Access Compliance Report

Public Rights-of-Way

Intersection ID: 14977	Main Street: BUCHANAN_ST	Cross Street: KENILWORTH_AV	Location: E
ADA ID: 0CF3AEA8B6B1	Ramp Type: Perp	Initial Pass/Fail: Fail	Overall Compliance: No
		Severity Score: 1.25

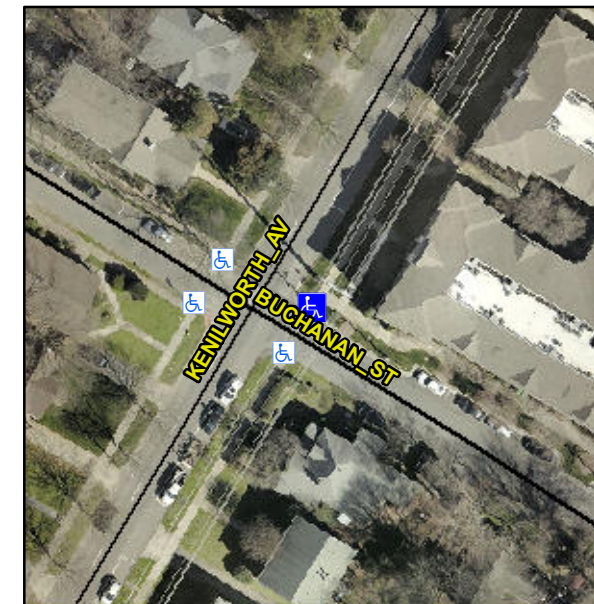
R304.5.3

Compliance	Description	Data	Compliance	Description	Data
N/A	Ramp Length (in)	59.0	Yes	Ramp Slope (%)	5.2
Yes	Ramp Width (in)	48.0	No	Ramp XSlope (%)	2.1
N/A	Flare Type LT	N/A	N/A	Flare Type RT	N/A
N/A	Flare Slope LT (%)	N/A	N/A	Flare Slope RT (%)	N/A
N/A	Flare Traversable LT?	N/A	N/A	Flare Traversable RT?	N/A
N/A	Landing Length (in)	N/A	N/A	DWS Provided?	N/A
N/A	Landing Width (in)	N/A	N/A	DWS Contrast?	N/A
N/A	Landing Slope (%)	N/A	N/A	DWS Length (in)	N/A
N/A	Landing X Slope (%)	N/A	N/A	DWS Full Width?	N/A
N/A	Landing Curb? (Y/N)	N/A	N/A	DWS Offset (in)	N/A
N/A	Shared Landing?	N/A			
N/A	Gutter Ponding?	N/A	N/A	Gutter Slope (%)	N/A
N/A	Gutter Lip Ht (in)	N/A	N/A	Gutter X Slope (%)	N/A
N/A	Painted X Walk1?	No	N/A	Painted X Walk2?	N/A
	X Walk 1 Direction	To SE		X Walk 2 Direction	N/A
N/A	X Walk 1 Width (in)	N/A	N/A	X Walk 2 Width (in)	N/A
	X Walk 1 Slope (%)	1.3		X Walk 2 Slope (%)	N/A
	X Walk 1 X Slope (%)	2.9		X Walk 2 X Slope (%)	N/A

Remove & Replace Entire Ramp.
